E1200535-v45

TMS WORK TO DO LIST GOING FORWARD

9-3-2013

PICTURES OF THE UK AT CALTECH, AND OUR DRAWING NOTE THE GUSSET

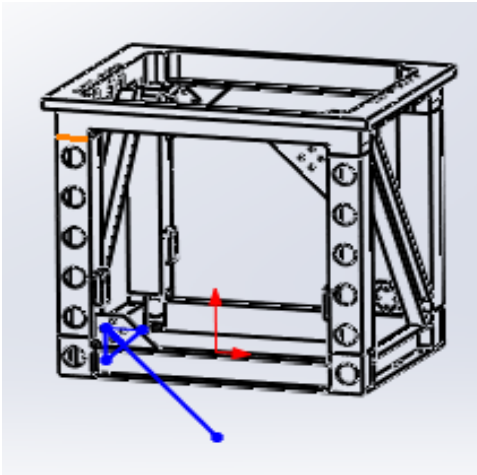
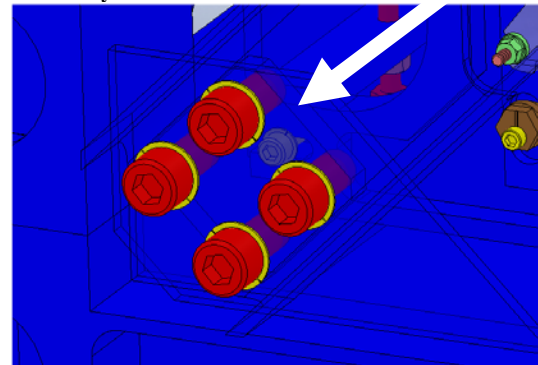
2. D060492 QUAD WELDED FRAME NEEDS TO BE UPDATED IN THE TMS DRAWING AND ASSEMBLIES TO SHOW THE 'UK' STYLE CONSTRUCTION.

THIS CORNER ATTACHMENT FOR THE CHANNEL STIFFENER WELDED IN BRACKET ATTACH POINT (4 PL) RATHER THAN THE NOW SHOWN GUSSET JUST WELDED IN THE CORNER ON THE SURFACE OF THE TUBE.

ALSO TO CHECK THE DRAWING FOR THE CHANNEL STIFFENER THAT THE PORT HOLE IS SHOWN FOR THE CONNECTOR CLEARANCE FOR THE BREADBOARD REF. 'UK' PART TD-1084-436

ACCESS TO THIS SCREW (SEE NOTE ABOVE) NOT needed anymore

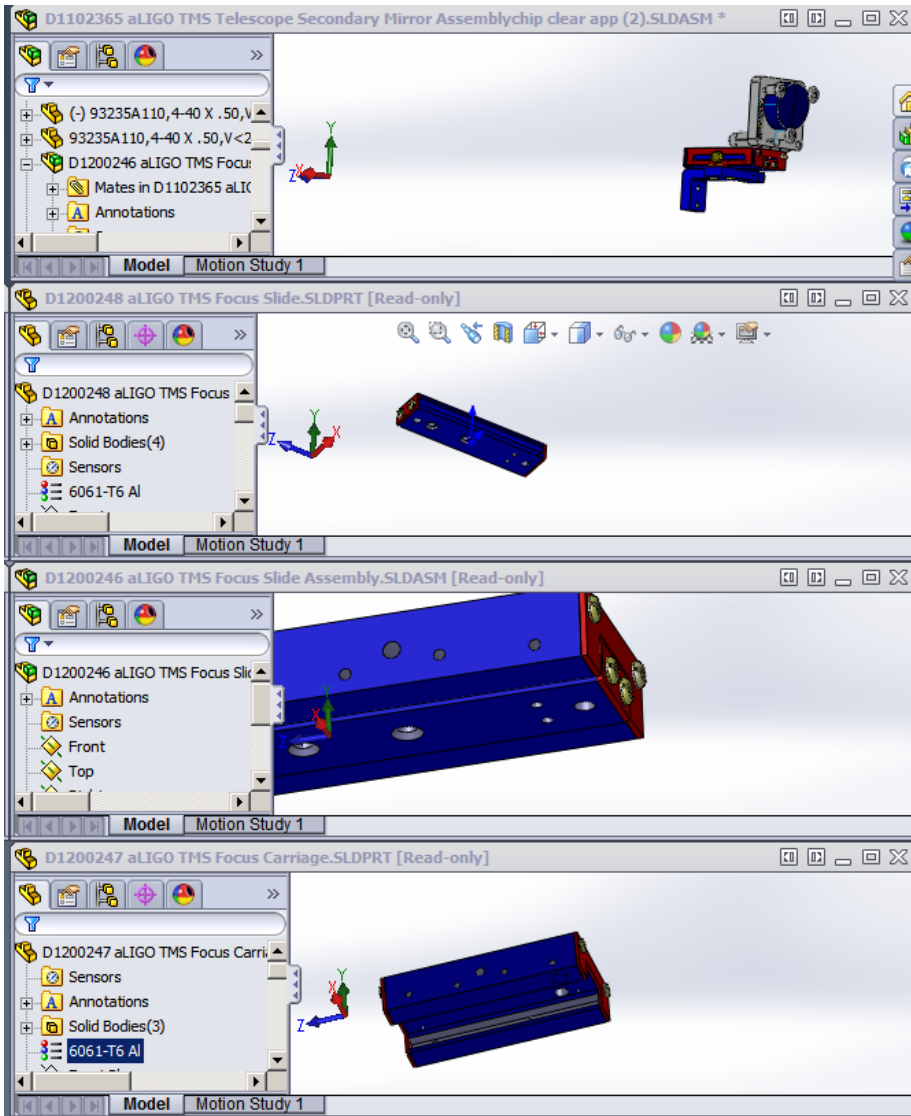
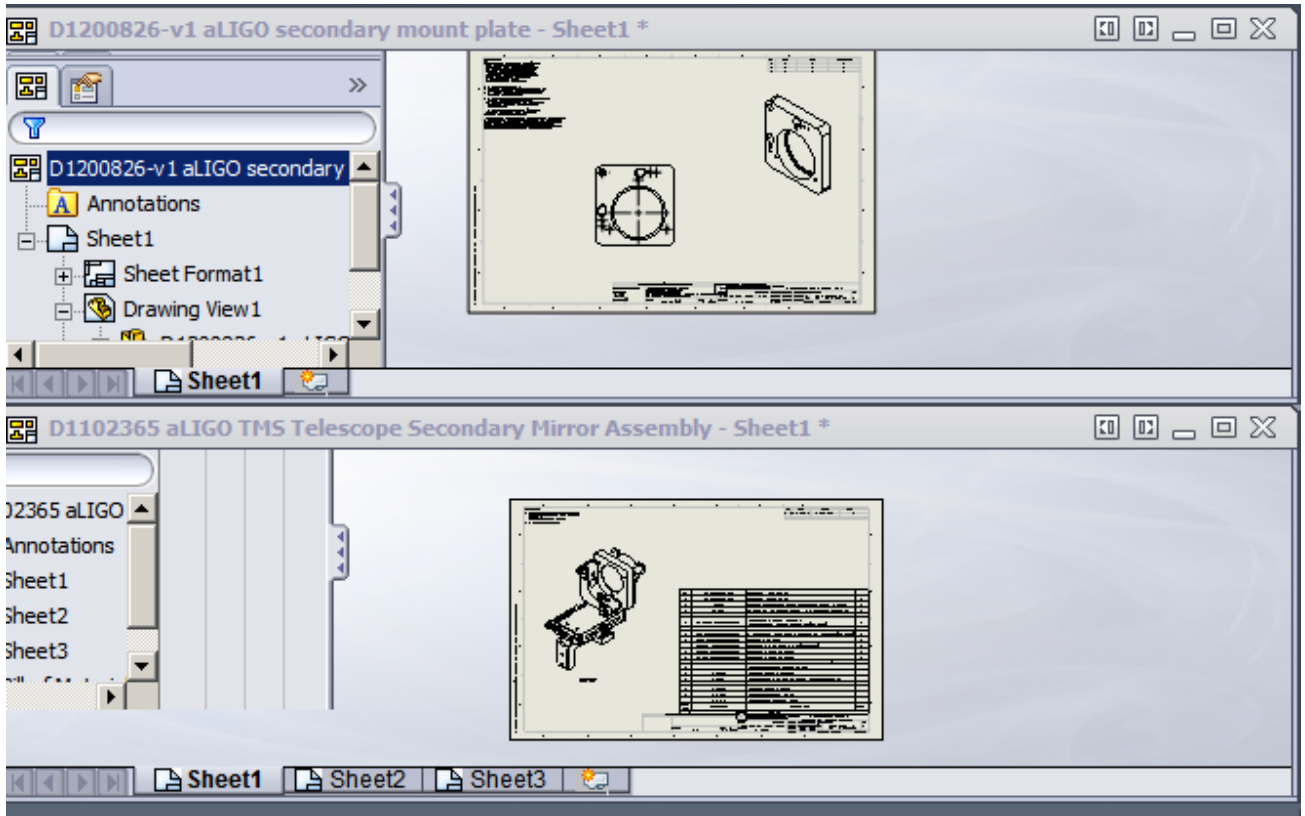
Calum,
after a good initial cleaning to get the mfg. dirt off,
last time we wiped it, with alcohol, while it was attached to the door, before we
attached it to the flanges.

this assembly is really outside, even more than the arm, it never touches anything in vacuum.
except for the tubes, everything is small, can be put in the sonic bath.

TYPE, SECONDARY MIRROR, MT. BRACKET			
REV.	DWG. NO.	DATE	REV.
v1	E1200321	26 MAR 2012	v2
v2		7 AUG 2012	
SCALE: 2:1	PROJECTION:	UC/US	SHEET 1 OF 1

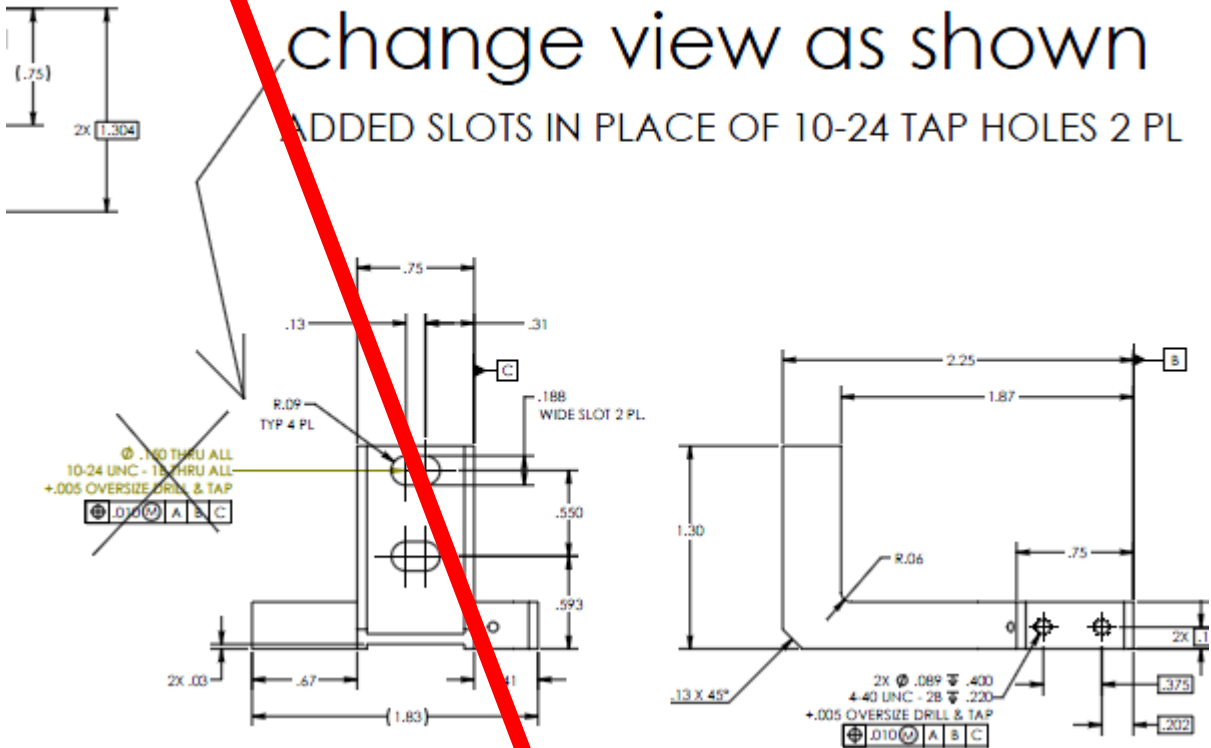
44. NOTE DIS REGARD this

and revert to the original v1 as built with the tapped holes new layout shows mirror centered

change view as shown
 ADDED SLOTS IN PLACE OF 10-24 TAP HOLES 2 PL

we need to order 92141a11 washers to work with this
 also longer stainless screws and silver or nickel nuts

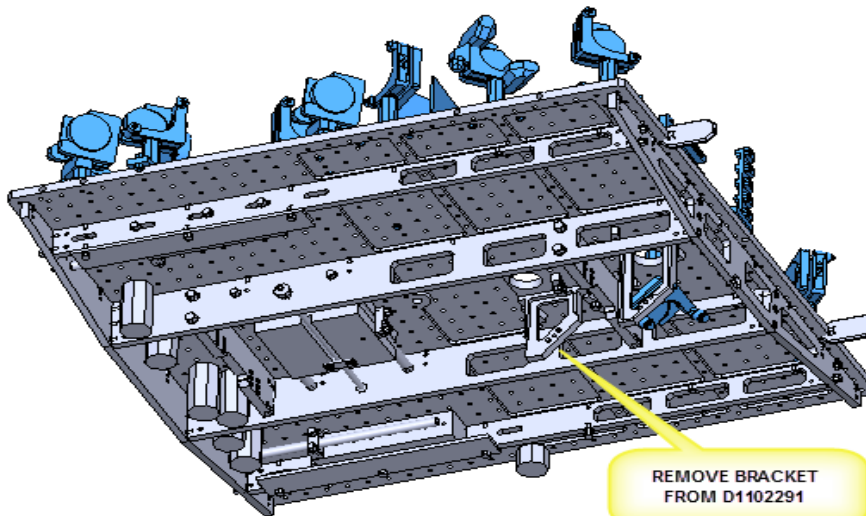
Sam,
were any parts removed from the top of the ICS table, in comparison to the first article.

i will remove the bracket, and sys. mount, and hardware pointed out below, from the table under side of D1102291

D1200244 MODIFIED HOLD DOWN SCREW aLIGO TMS F1 Mirror Assembly.SLDASM

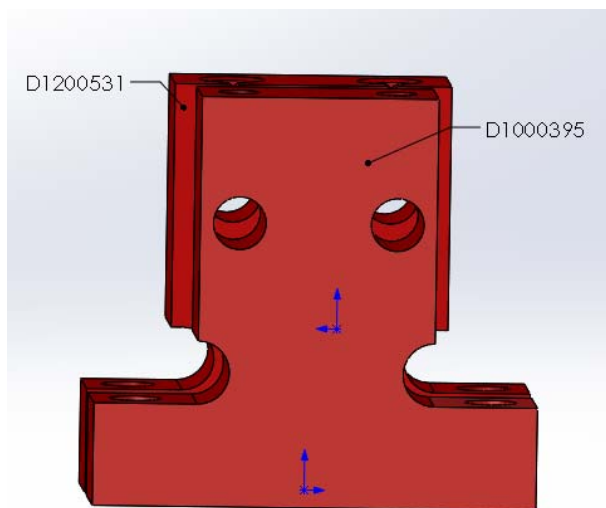
to add a button head or truss head to hold down the adjusting screw
the shcs does not engage reliably.
